TITLE: 15-0-15V PSU		REV: 1.1
EasyEDA	Company: Robert Jenkins (C) 2021	Sheet: 1/1
	Date: 2021-02-28	Drawn By: Robert Jenkins

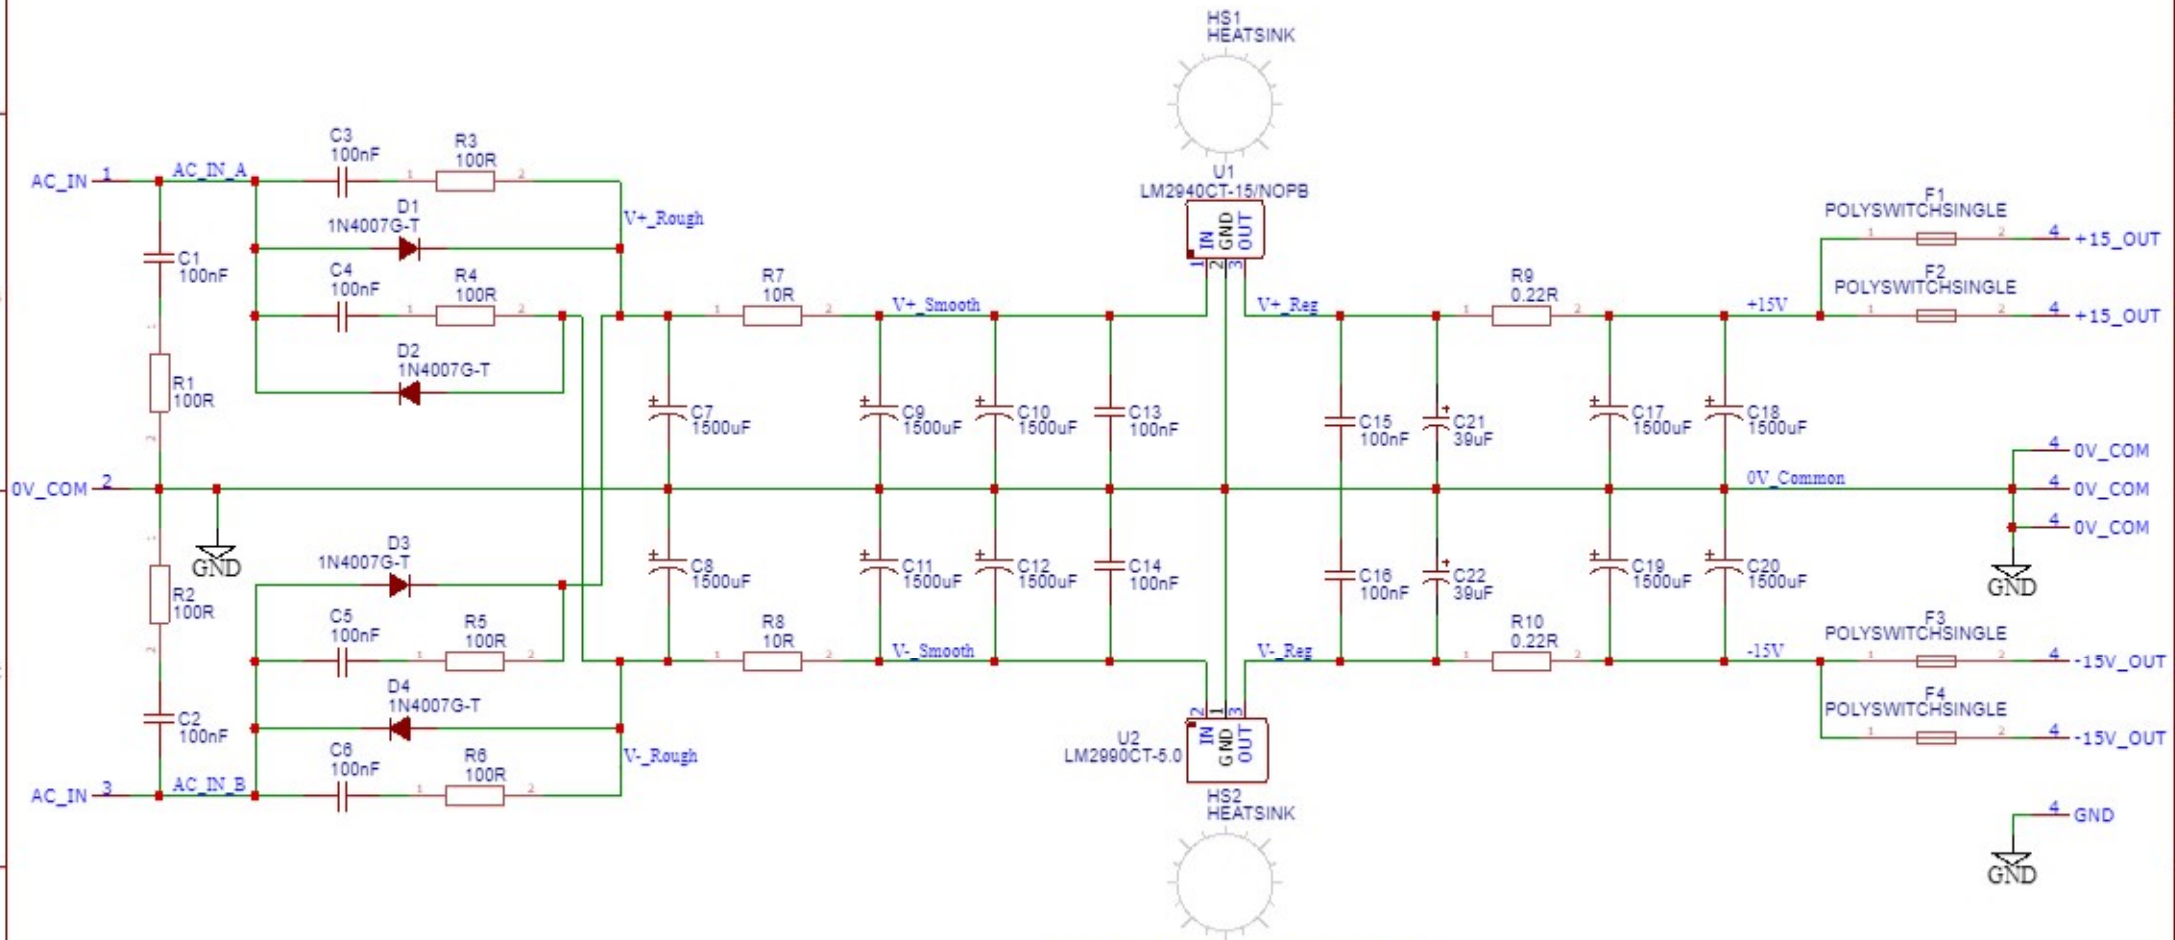
Version 1.1 - R9 & R10 added to comply with regulator minimum load ESR requirements.
No problems were seen with V1.0 PCBs, which did not have those included.
The addition is to ensure stability with different batches or versions of regulators.
